**Sherpa's Response to Advisian Peer Review of *Quantitative Risk Analysis Report Bulk Storage Facilities, Lyttelton Port* (doc ref 21026-RP-002 Rev 0 September 2016**

Advisian, *Peer Review of Quantitative Risk Analysis Report Bulk Storage Facilities, Lyttelton Port November 2016*, doc ref: 170396-RPT-X0001-R1.

Figure 1: Comparison of Total Ignition Probabilities – Liquid, Various Sources

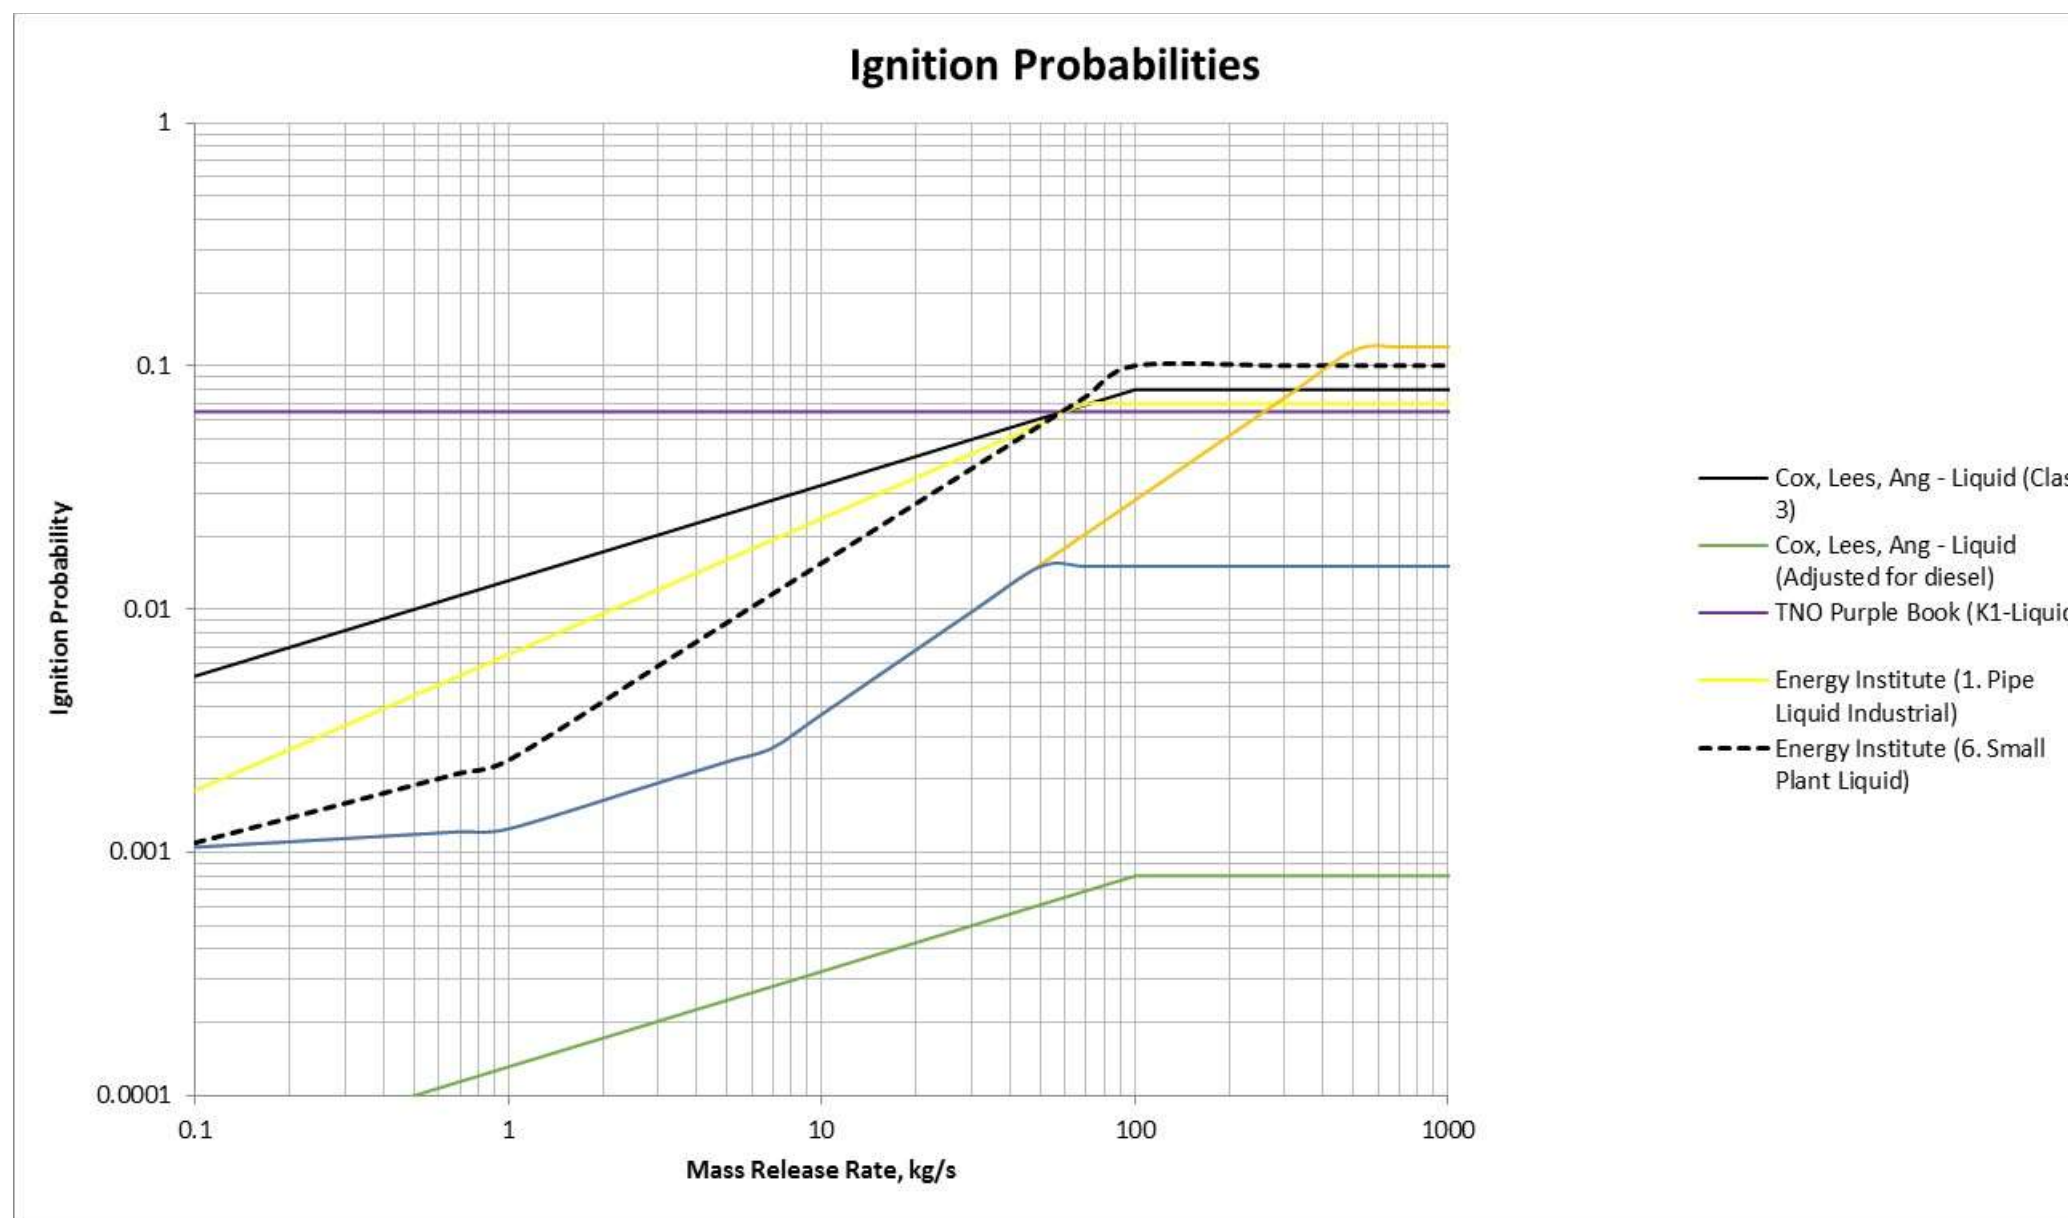
Response Number	Advisian Item	Item	Sherpa Response (NOTE: QRA report cross references refer to Sherpa's report <i>Quantitative Risk Analysis Report Bulk Storage Facilities, Lyttelton Port</i> doc ref 21026-RP-002 Rev 0 September 2016)	Sherpa assessment of impact on QRA results
1	Exec Summary page iv 1 <sup>st</sup> bullet pt	<ul style="list-style-type: none"> <li>The cumulative QRA report was prepared as per good industry practice and was based on the agreed database, information and assumptions. However, the calculated risk was seen to be on a caution side due to the assumptions and selected database.</li> </ul>	<p>As no specific assumptions or databases are referred to here, Sherpa is not able to respond to the comment that the calculated risk was "seen to be on a caution side". Comments that imply conservatism are addressed in subsequent sections of this response.</p> <p>In Sherpa's view, QRAs for use in land use planning should be based on conservative assumptions, hence a precautionary approach with stated assumptions has been presented.</p>	None

Total Ignition Probability Data Used in QRA:

Cox, Lees, Ang - Gas		Cox, Lees, Ang - Liquid (Class 3)	Cox, Lees, Ang - Liquid (Adjusted for diesel)
Mass Rate (kg/s)	Ign Prob	Ign Prob	Ign Prob
0.1	0.0035	0.005	5.3E-05
10	0.07	0.032	0.00032
100	0.3	0.08	0.0008
Rupture	1	0.08	0.0008
